A. Project Name: Nur-UI-Islam

B. Project Address: 10600 SW 59 Street, Cooper City, FL 33328

Nur-UI-Islam – Site Plan Amendment and Variance DRC Comment Responses

**Applications # SPA 10-1-21 & Variance # 10-6-21
Site Plan Amendment and Variance Application
Agent: Greenspoon Marder, LLP (Elizabeth Adler)**

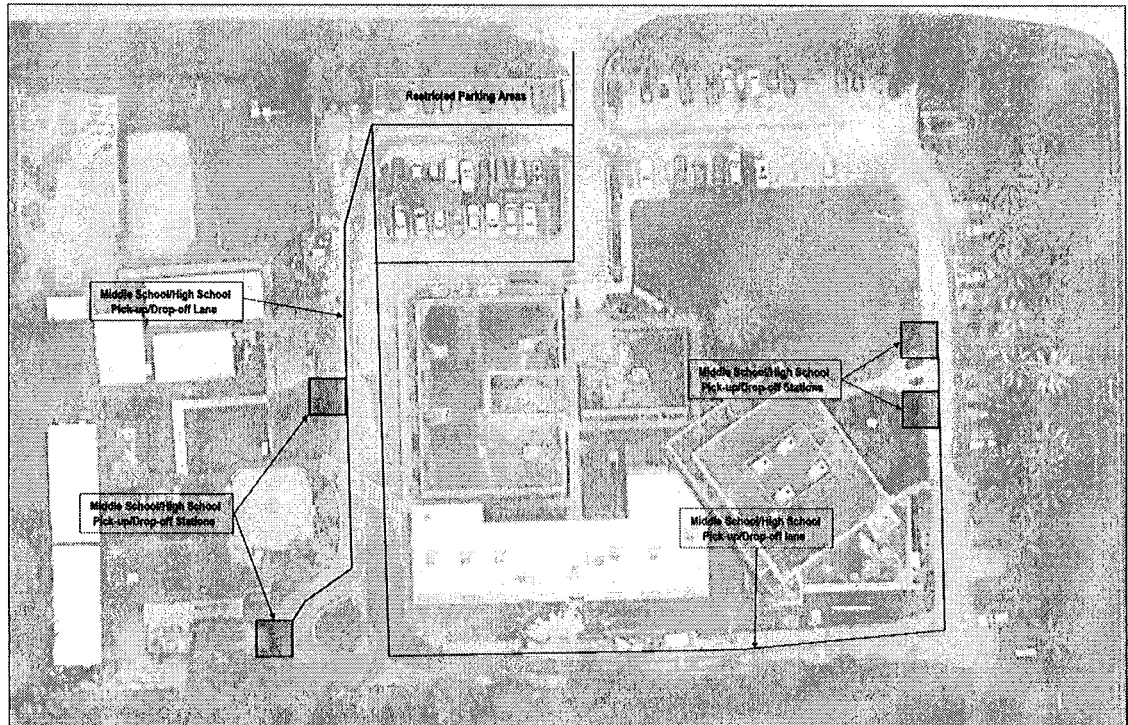
Response:	Section 9.0 has been updated.
Comment:	12. The applicant shall update the traffic study to include a queueing study of the arrival and drop off at the existing school with current enrollment. There needs to be further backup justification of the 4 observed vehicles in queue out of 153 vehicles and the percentage of parents using the drop off and using the onsite parking spaces. Based on

<p>recent field observations and historical queuing, there has been vehicles staked off site on to SW 106th Avenue during peak arrival/dismissal times. An aerial drone image of the onsite vehicle stacking should be provided during this queue study to document the queue impact to the adjacent road network.</p>

Response:	<p>The queuing analysis section 11.0 was revised. In addition, field reviews were conducted on Thursday December 9, 2021 and Friday December 10, 2021. Field review observations and images can be found in attachment A of this respond memorandum.</p>
